BUILDING CODE OF AUSTRALIA REPORT

28 LOCKWOOD AVE

Four storey mixed used building over a basement

Report: **BCA342032-R1.1.2**

Basement 02

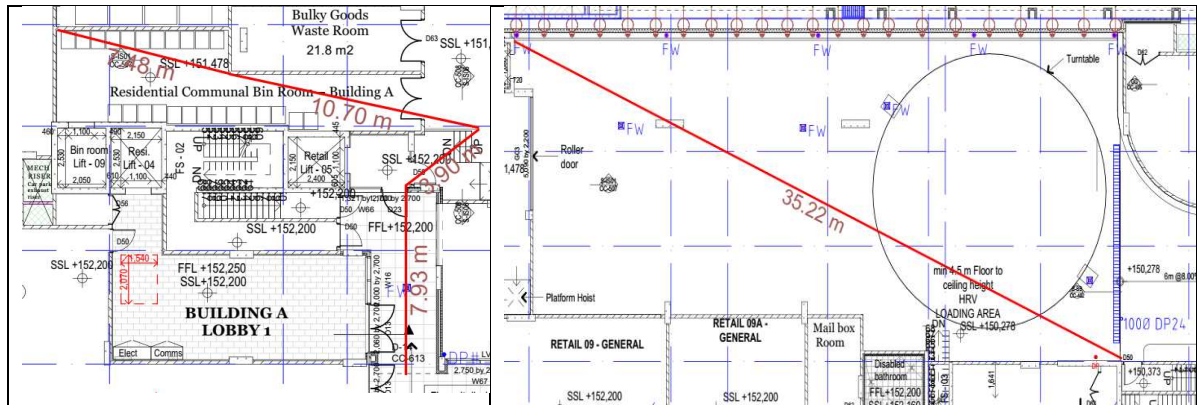
Providing that stairs connecting the central courtyard with Glen Street are not covered, the central courtyard is an open space connected to the road.

- Travel distance in the residential bin room is more than 20 m to an exit (open space), 30.5 m
- Retail waste room – travel distance is more than 20 m to an exit (35.5 m).

A modification of the design or performance solution is required to address these deviations.

Lower Ground Level

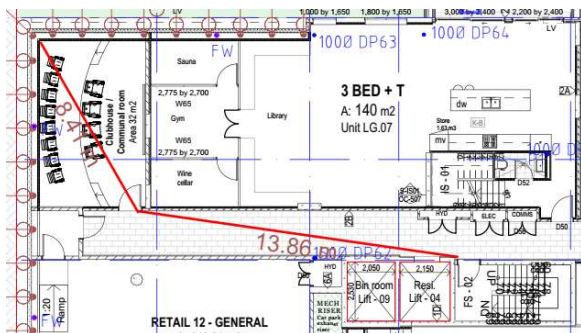
Communal room - over 20 m to the nearest exit, up to 22.5 m.

Travel distance from doorways of units LG 16 and LG 17 to the single exit exceeds 12 m (15.0 m)

Ground Level

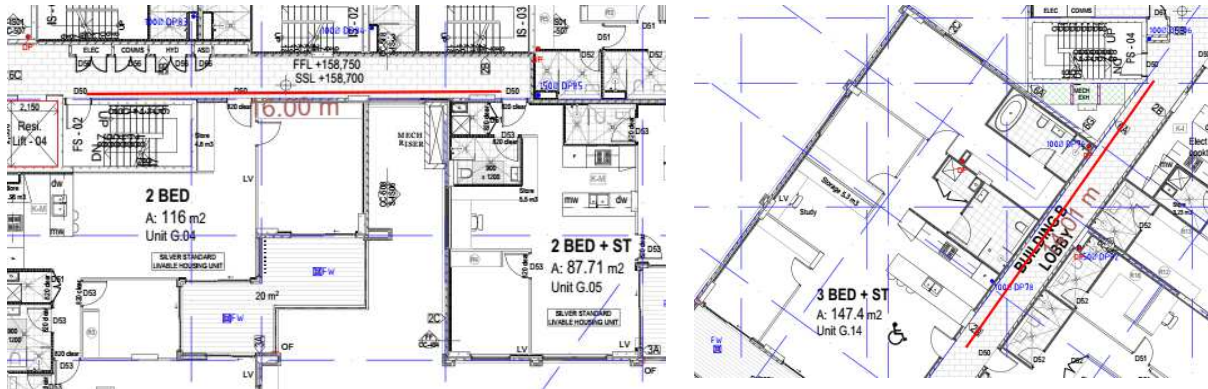
- Building A lobby 1, Unit G05 – over 12 m to a single exit, up to 15.5 m.
- Building B lobby, Unit G14 – over 12 m to the point where travel towards two exits is available, up to 14 m.

Level 01

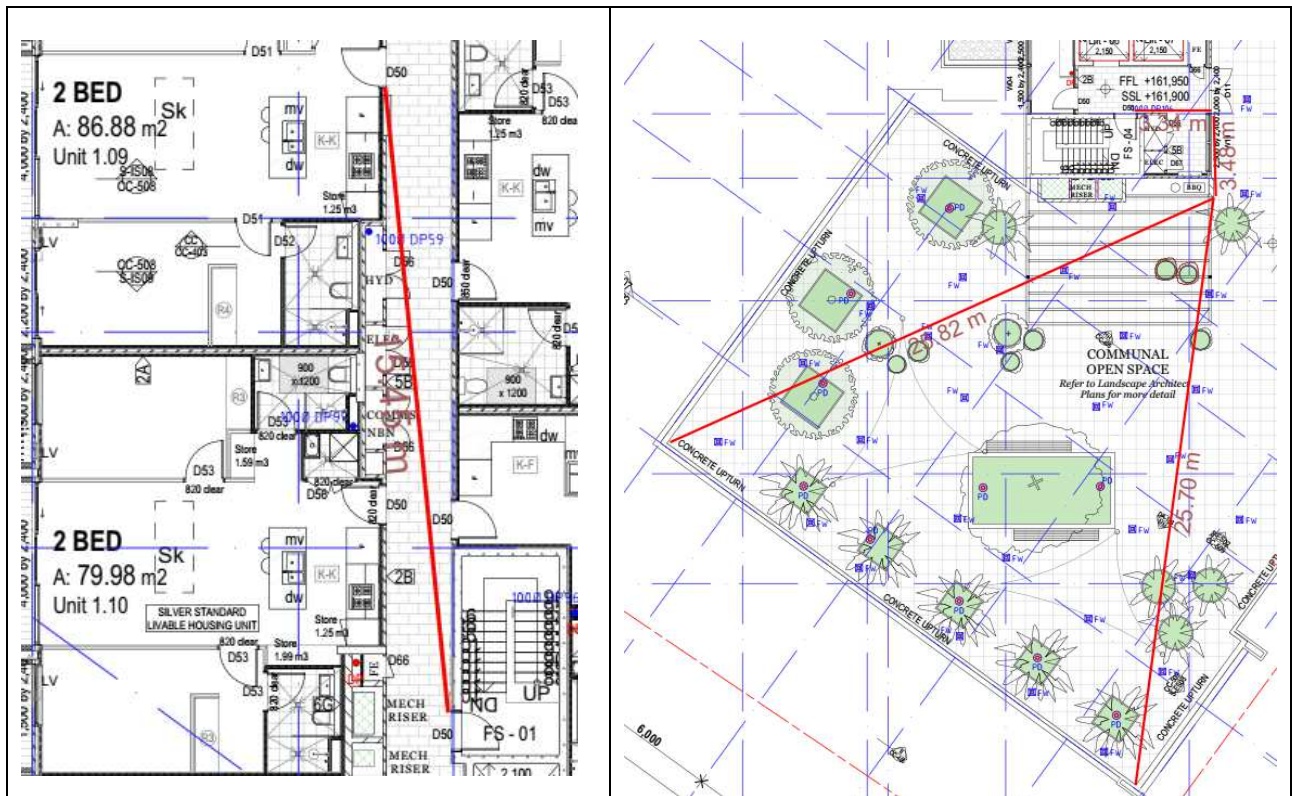
- Building A lobby 2 – over 12 m to a single exit, up to 15.5 m.
- Occupiable outdoor area - over 20 m to a single exit, up to 33 m.

D2D12 Travel via fire-isolated exits

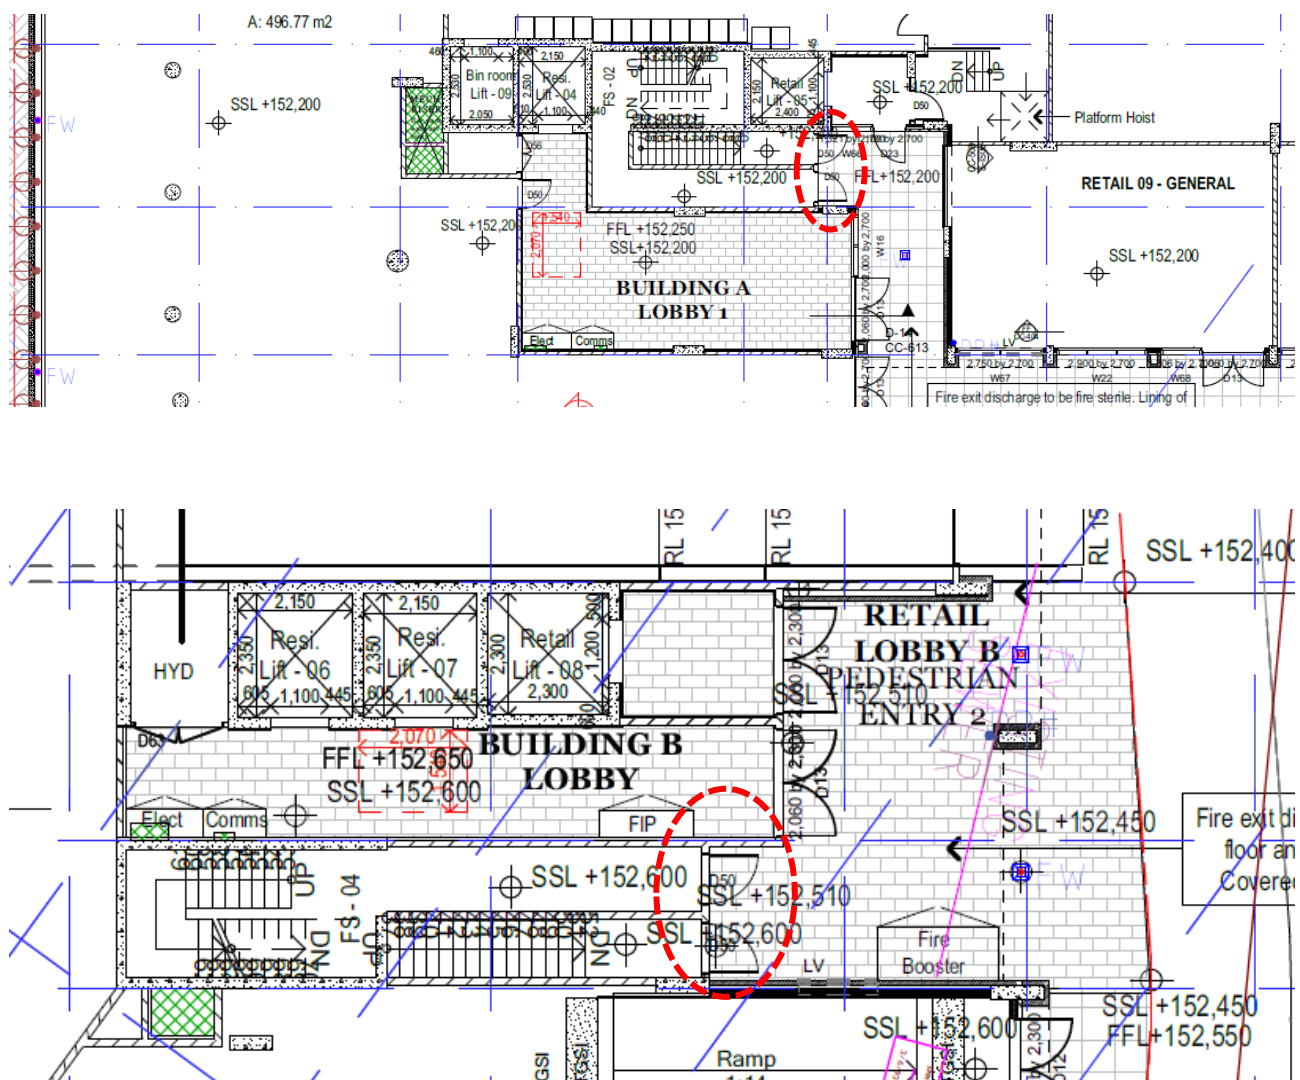
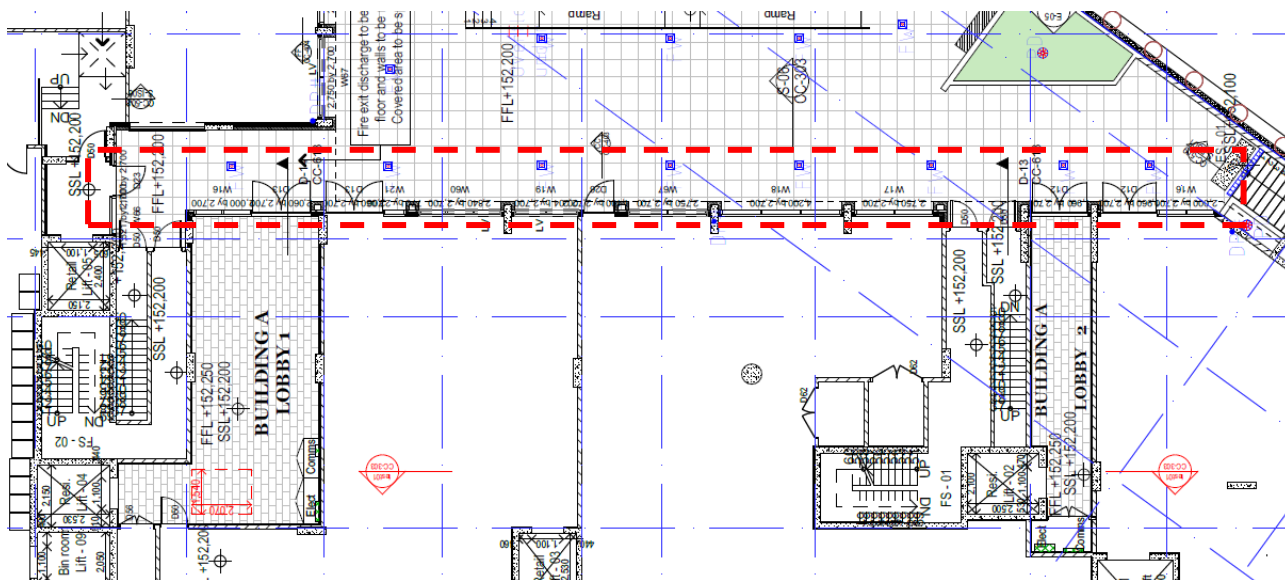
Plans show the fire isolated exits next to Building A lobby 1, and also the Building B lobby, discharge within the confines of the building,, an area not open to 2/3 of its perimeter as shown below. A modification of the design or performance solution is required to address these deviations.

The path of travel from the fire isolated stairs at Building A lobby 1 & 2 also passes within 6 m of openings in an external wall, shown below. A modification of the design or performance solution is required to address this deviation.

D3D25 Swinging doors

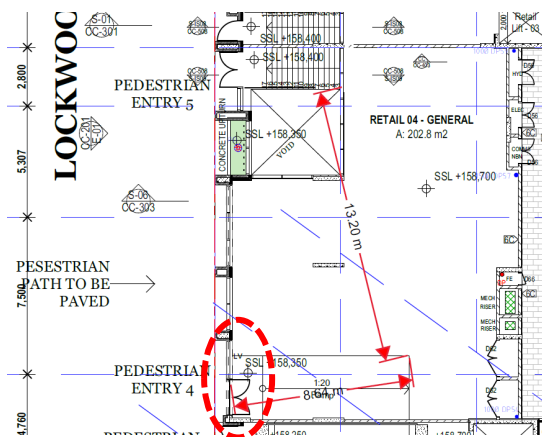
Plans show doors at several retail tenancies 2, 3 and 4 and retail lobby that swing against egress and it is noted that compliance is achievable at these parts where the door is held open by a device. A modification of the design or performance solution is required to address these deviations.
